Access Compliance Report

Public Rights-of-Way

(Curb Ramps)

Intersection ID: 11344	Main Street: N_TRYON_ST	Cross Street: W_LIDDELL_ST	Location: N
ADA ID: 3EFDEE4D1257	Ramp Type: PerpDiag	Initial Pass/Fail: Fail	Overall Compliance: No
Severity Score: 37.5			
Codes/Mitigation Info/Possible Solution		Field Measurements/Component Compliance

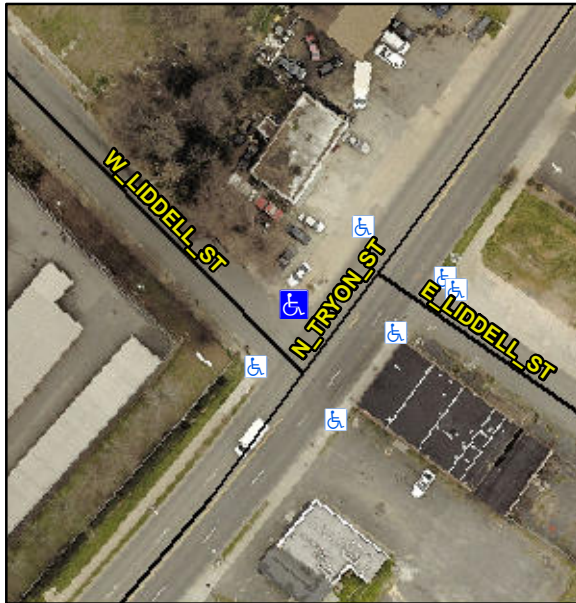
R304.2.2, R304.5.3

Compliance	Description	Data	Compliance	Description	Data
N/A	Ramp Length (in)	79.0	No	Ramp Slope (%)	9.7
Yes	Ramp Width (in)	48.0	No	Ramp XSlope (%)	8.8
N/A	Flare Type LT	N/A	N/A	Flare Type RT	N/A
N/A	Flare Slope LT (%)	N/A	N/A	Flare Slope RT (%)	N/A
N/A	Flare Traversable LT?	N/A	N/A	Flare Traversable RT?	N/A
N/A	Landing Length (in)	N/A	N/A	DWS Provided?	N/A
N/A	Landing Width (in)	N/A	N/A	DWS Contrast?	N/A
N/A	Landing Slope (%)	N/A	N/A	DWS Length (in)	N/A
N/A	Landing X Slope (%)	N/A	N/A	DWS Full Width?	N/A
N/A	Landing Curb? (Y/N)	N/A	N/A	DWS Offset (in)	N/A
N/A	Shared Landing?	N/A			
N/A	Gutter Ponding?	N/A	N/A	Gutter Slope (%)	N/A
N/A	Gutter Lip Ht (in)	3.0	N/A	Gutter X Slope (%)	N/A
N/A	Painted X Walk1?	No	N/A	Painted X Walk2?	No
	X Walk 1 Direction	To SW		X Walk 2 Direction	To SE
N/A	X Walk 1 Width (in)	N/A	N/A	X Walk 2 Width (in)	N/A
	X Walk 1 Slope (%)	7.8		X Walk 2 Slope (%)	3.1
	X Walk 1 X Slope (%)	5.9		X Walk 2 X Slope (%)	7.8

Remove & Replace Curb Ramp With Two New Directional Ramps or Equivalent.
